Planning Commission Staff Report

SUBJECT: DR18-39, MELODY INDUSTRIAL BUILDING

Approve the Findings of Fact and approve DR18-39, Melody Industrial Building: Site plan, landscaping, grading and drainage, elevations, floor plans, lighting, colors and materials for approximately 0.63 acres, generally located at the northwest corner of Hobson Street and Melody Avenue and zoned Light Industrial (LI) with a Planned Area Development (PAD) overlay.

SITE PLAN 1" = 10'-0"

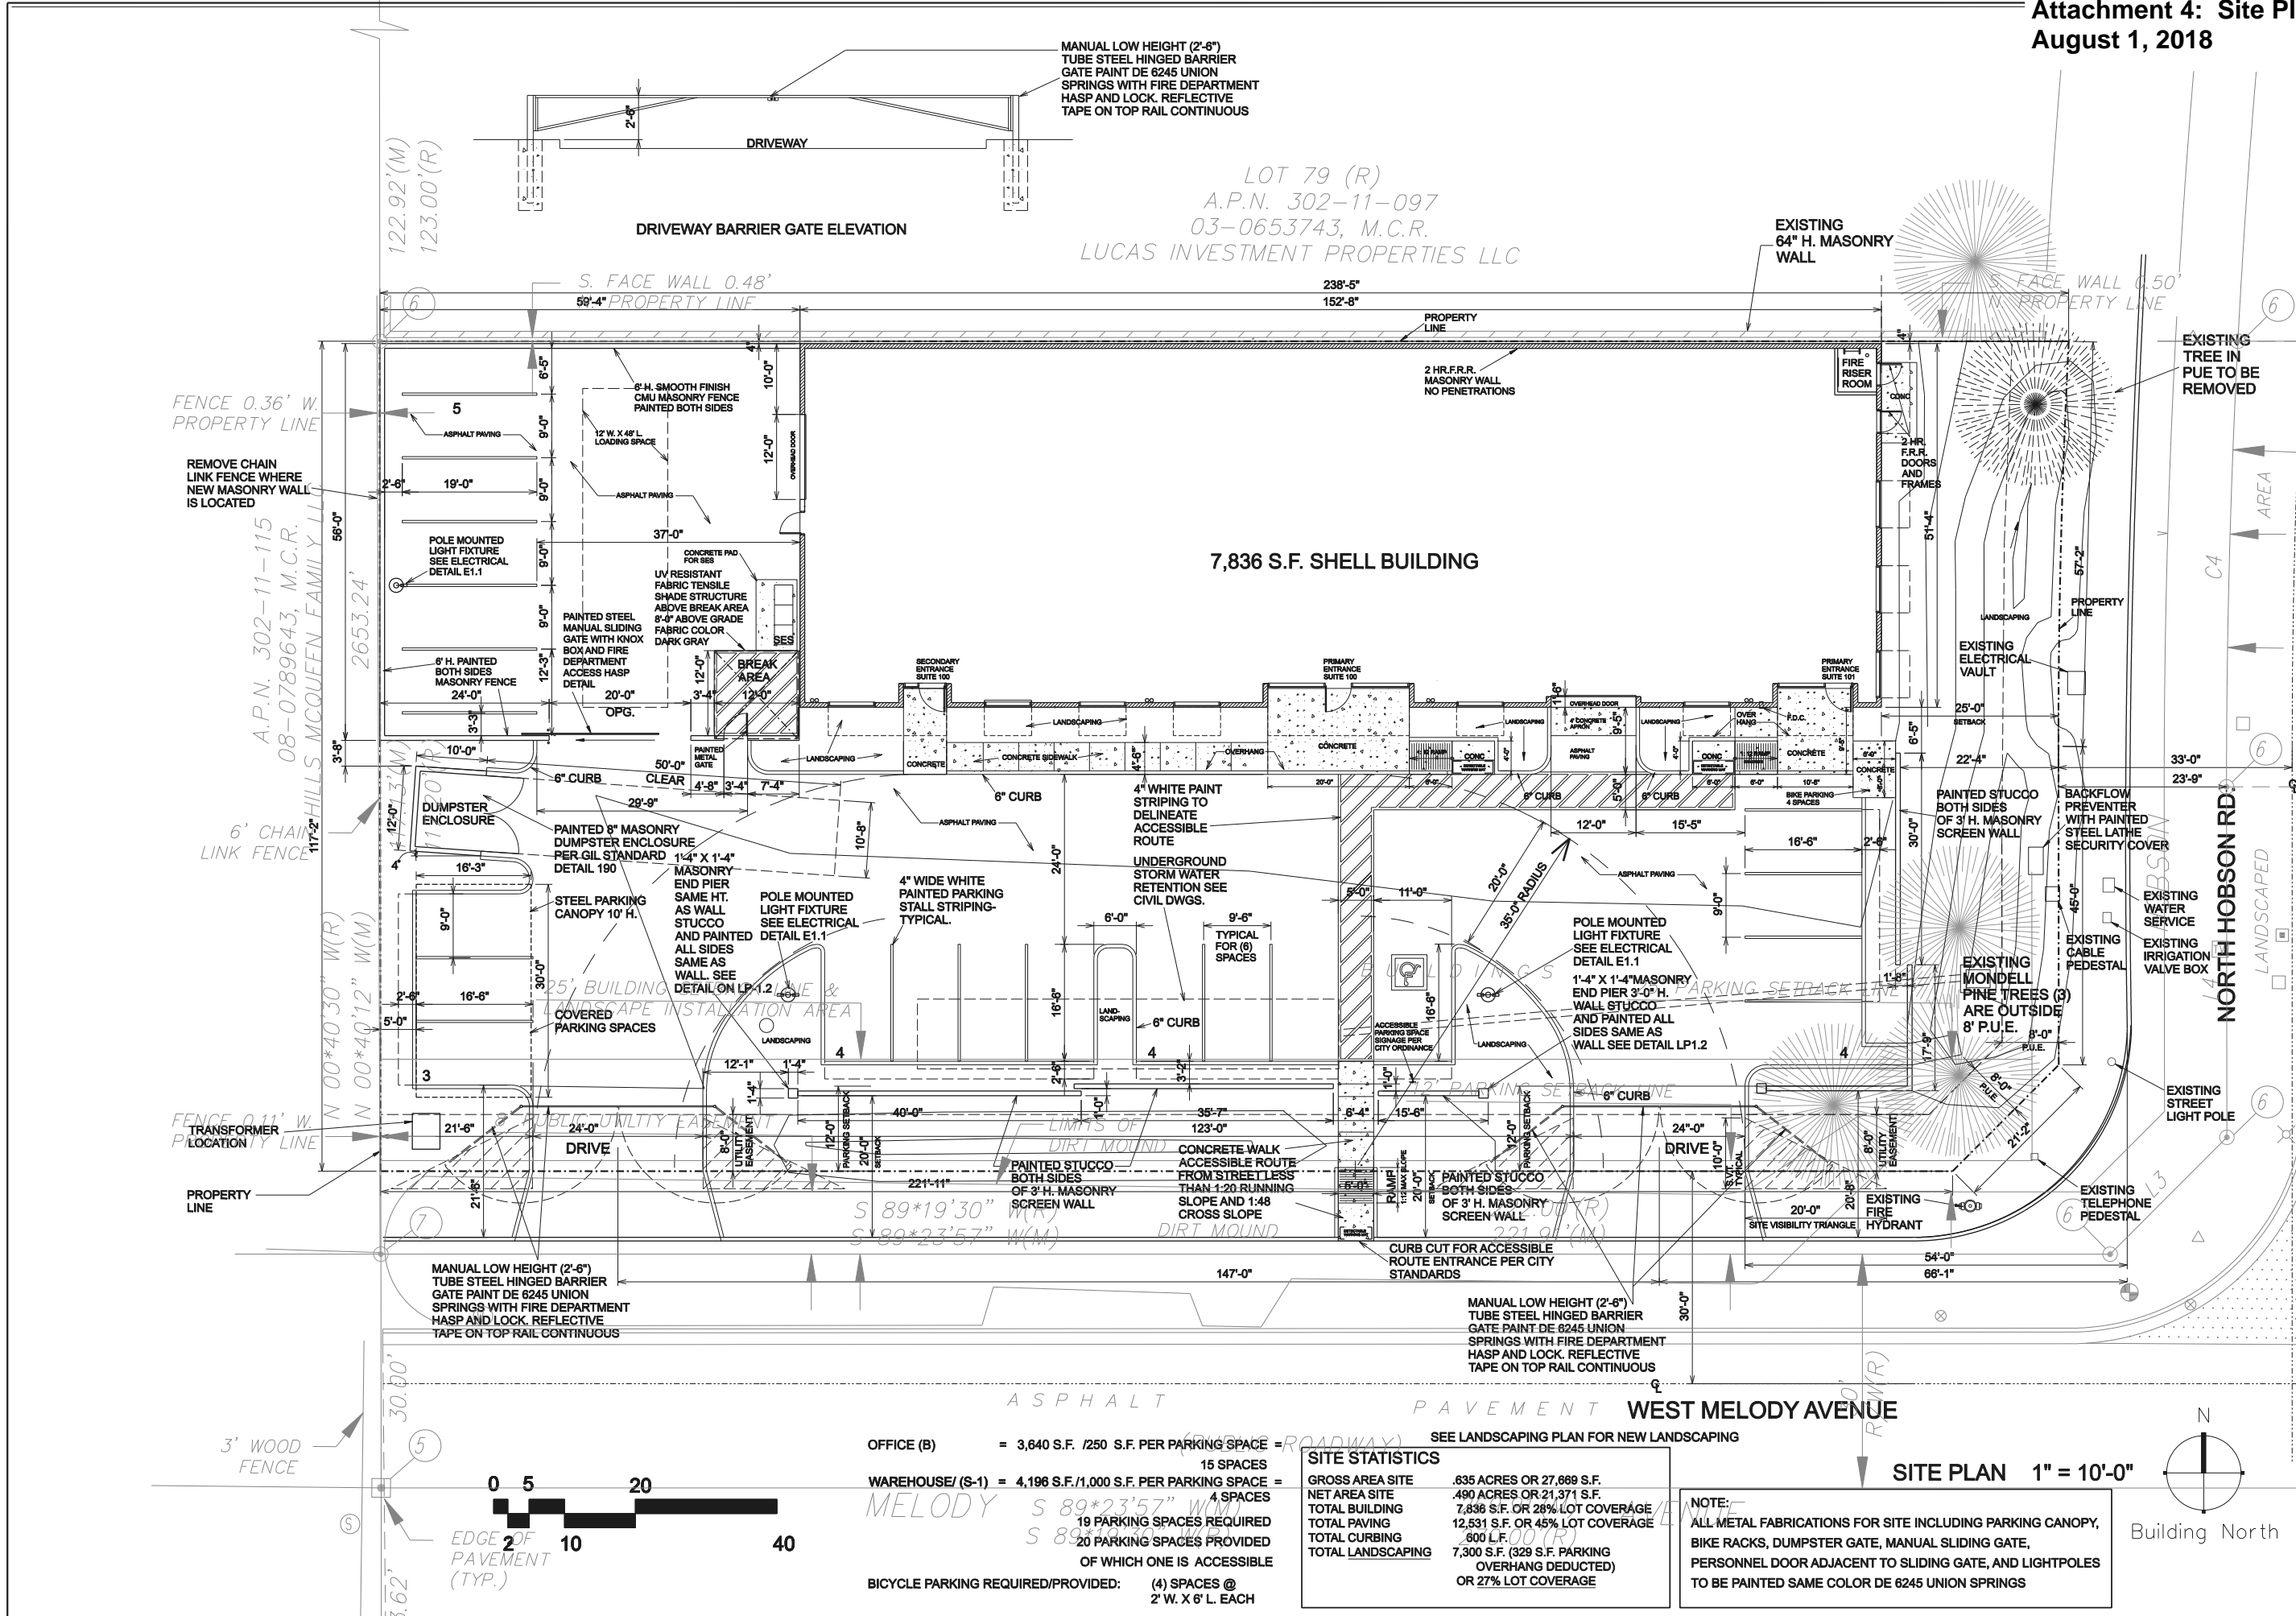
- Commissioners discussed the proposed 5’ building setback at the rear of the property along the north property line and whether or not the building could be located on the rear property line and have a 0’ setback if a Variance was approved, which would eliminate an unnecessary space behind the building.

- Commissioners questioned the location of the ADA accessible route, along the front of the building, proposed to go through the drive aisle along the south side of the building. It was suggested the building be moved to the north along the property line so they will have room for the accessible route.

- Staff has determined that a 0’ setback along the north property boundary is permitted per the LDC and the applicant has moved the building accordingly.

- The applicant has moved the building 5’ to the north so as to be constructed on the property line. The additional 5’ has now provided additional room for a sidewalk and more appropriate ADA accessible route, which is now shown along the entire south side of the building.

PRELIMINARY GRADING & DRAINAGE PLAN

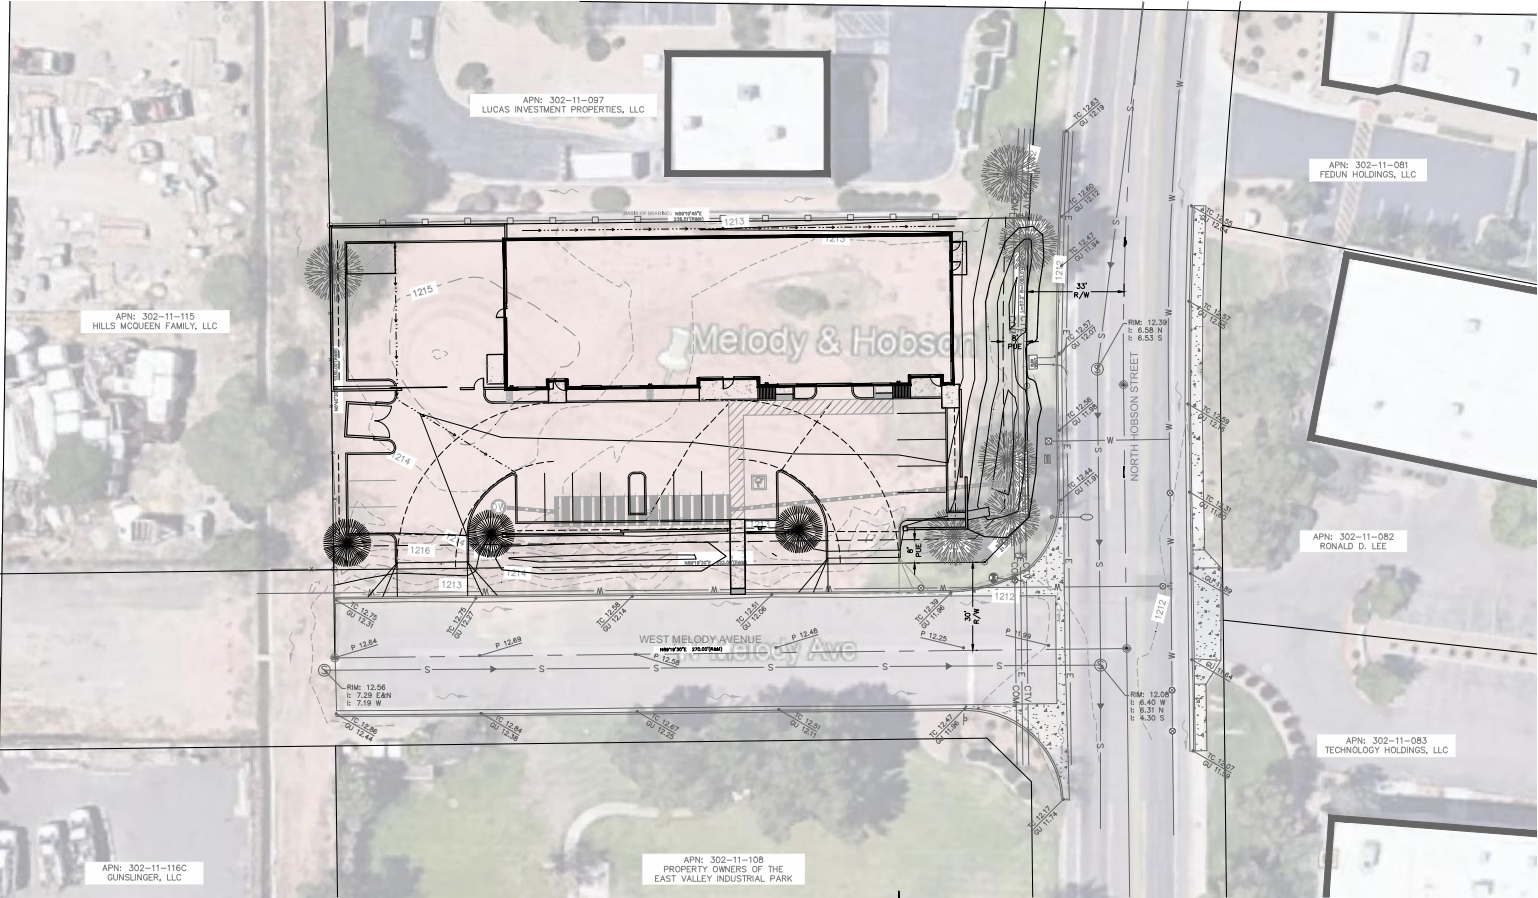
5. A revised Grading and Drainage Plan, reflecting the building being shifted to the north property line, shall be submitted for review and approval by Town Staff prior to the submittal of construction documents.

COLOR ELEVATIONS

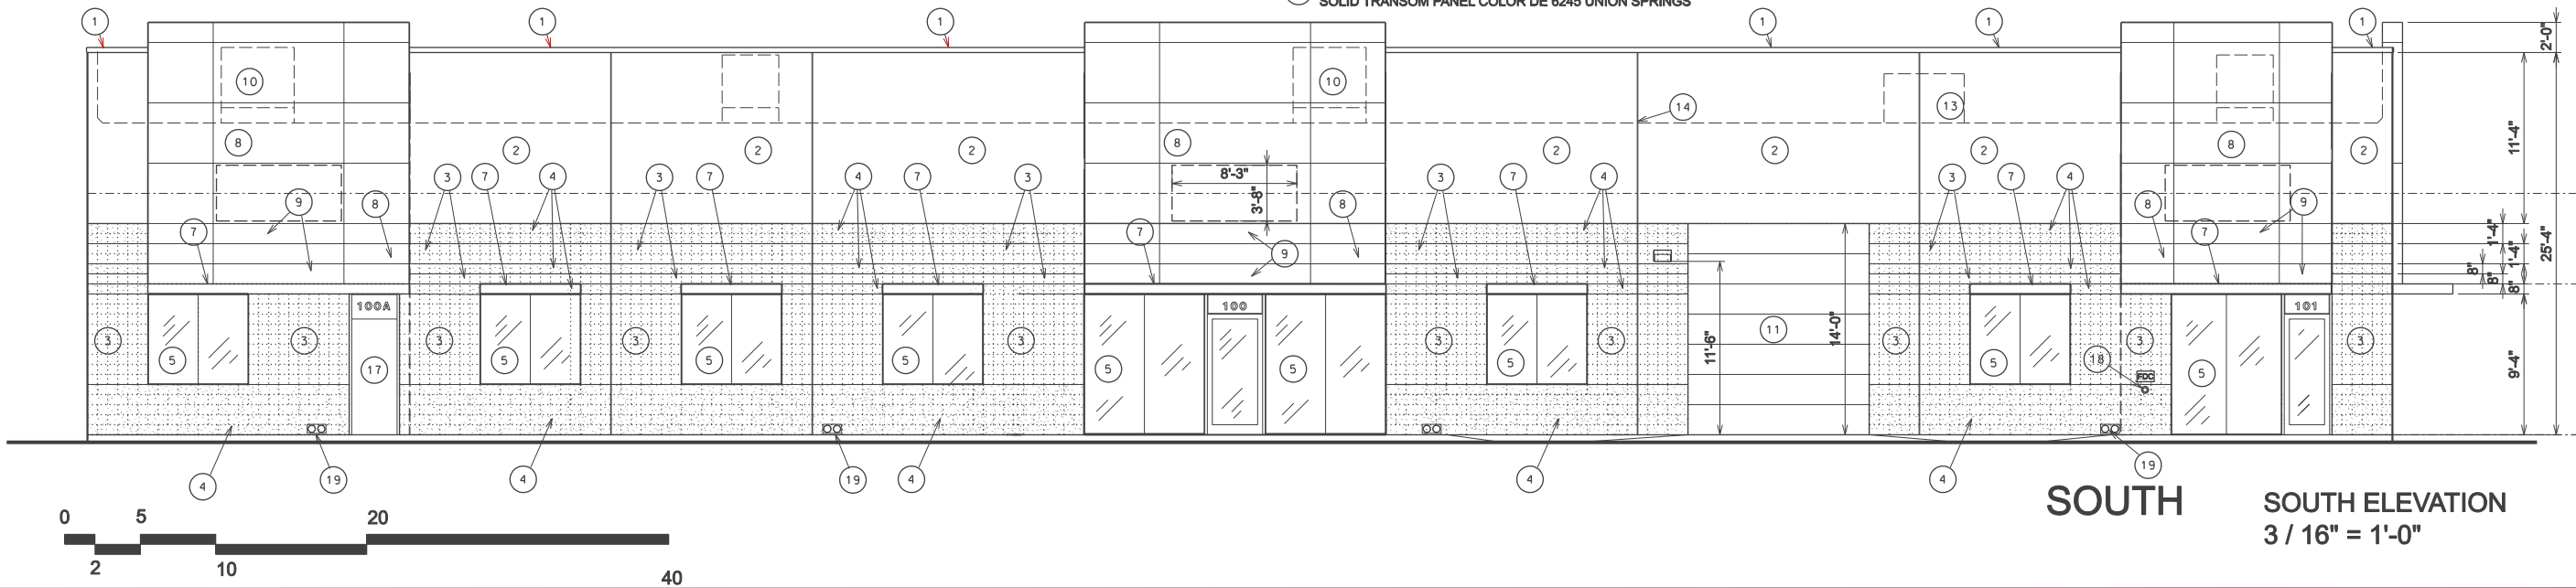
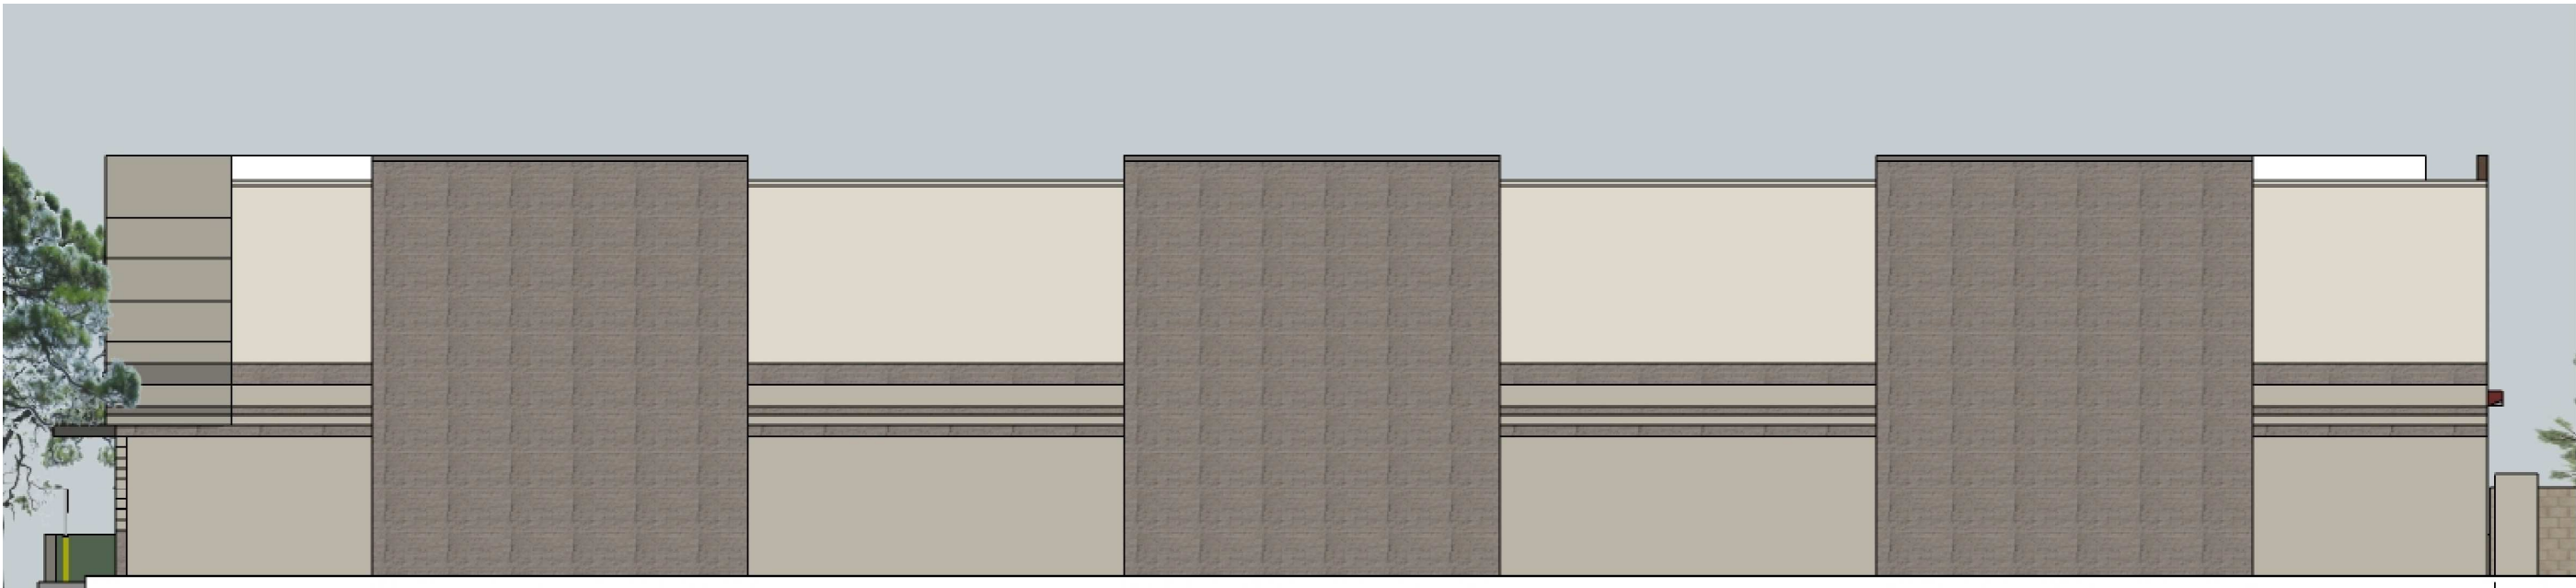
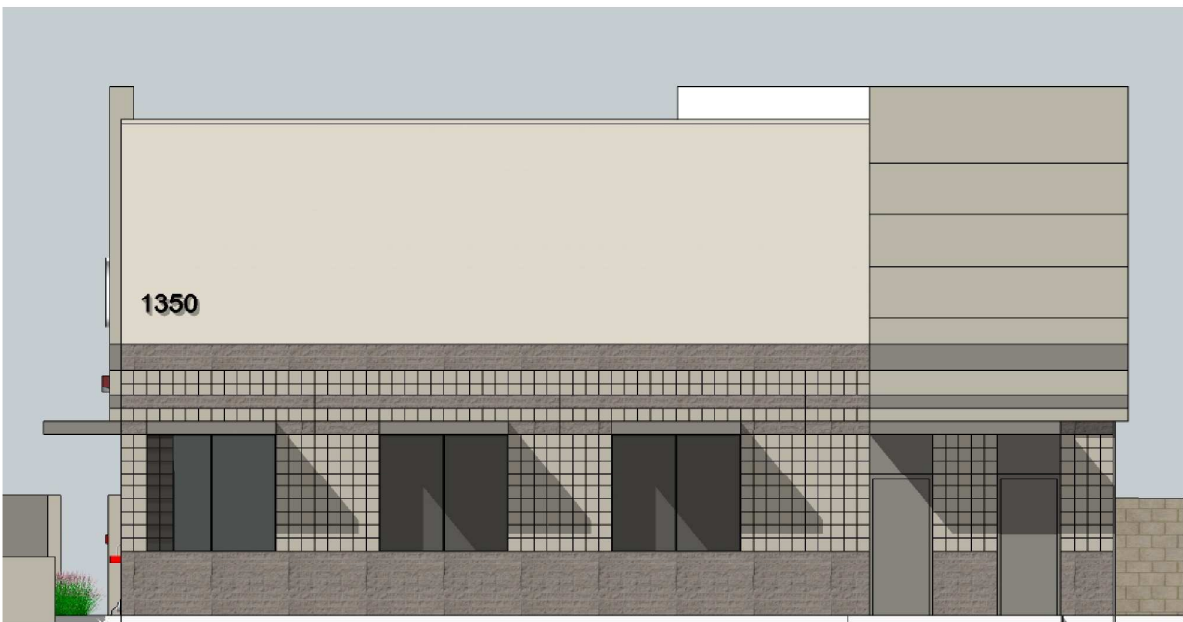
- Commissioners discussed the rear of the building and that the additional design elements should be brought to the ground instead of stopping halfway down the building wall.
 - The applicant revised the design of the north elevation by providing split face and smooth face CMU block finishes and two different paint colors all the way to the ground along the entire elevation.
- Commissioners discussed whether or not sufficient fire access was being provided along the north side of the building.
 - Staff has confirmed with the Fire Department that sufficient fire access to the north side of the building has been provided.
